Work Order ID 128654

Item ID: D5159-045

Item Name: Seat Rib Assembly

A		NEW ISSUE		AJS	14.09.24
REV.	DESCRIPTION			BY	DATE
DESIGN	AJS	DART AEROSPACE LTD			
DRAWN	AJS	HAWKESBURY, ONTARIO, CANADA			
CHECKED	AP	DRAWING NO.	D5159	REV. A	
MFG. APPR.	DD	TITLE	SEAT BRACE ASSY	SHEET 1 OF 3	
APPROVED	HS			SCALE	
DE APPR.	DS			NTS	
DATE	14.09.24		COPYRIGHT © 2014 BY DART AEROSPACE LTD THIS DOCUMENT IS PRIVATE AND CONFIDENTIAL AND IS SUPPLIED ON THE EXPRESS CONDITION THAT IT IS NOT TO BE USED FOR ANY PURPOSE OR COPIED OR COMMUNICATED TO ANY OTHER PERSON WITHOUT WRITTEN PERMISSION FROM DART AEROSPACE LTD.

D5159-045 SEAT RIB ASSY

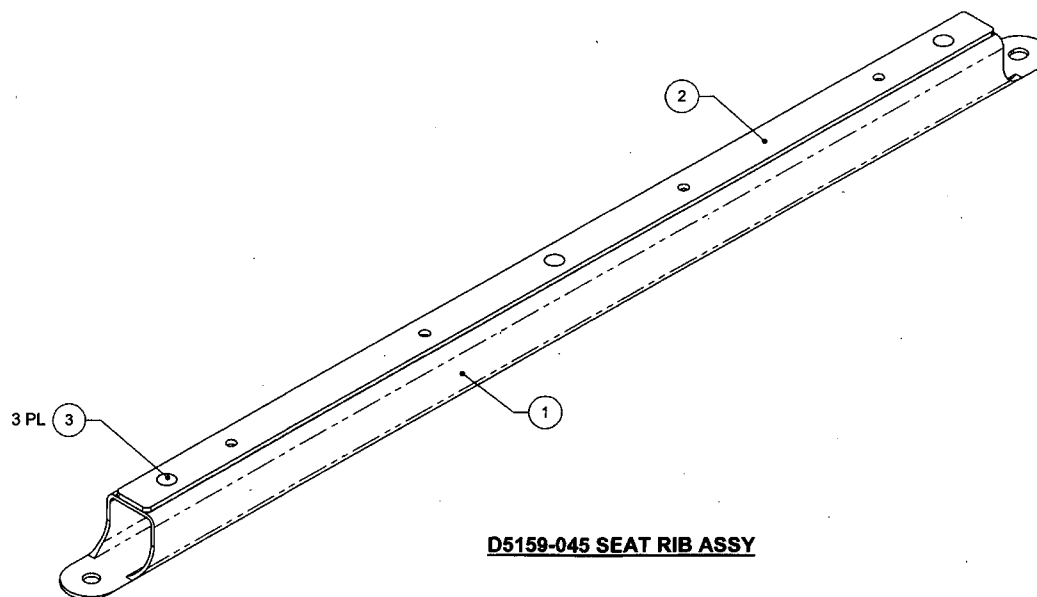
Root Cause	Date	Step	Qty	Description of work order update or non-conformance	Initial Chief Eng	Action Description	Sign & Date	Verification	QC Inspector
Design	15.02.20	110	8	DS159-045 IS CAN NOT BE INSTALLED WITH MS20801M4W4 RIVETS AS THERE ARE NONE IN STOCK	A.P. 15.02.20	ACCEPTABLE TO SUBSTITUTE CR3212-4-3, SINCE SLEEVE IS ALUMINUM INSTALL WET WITH PROSEAL 890			
Doc/Data									
Equip/Tooling									
Handling/Pre									
Material									
Operator									
Offset/Setup									
Process									
Supplier									
Training									
Transport									
Unapproved

Proseal P/S 890 0-2
alum rivets CR3212-4-3
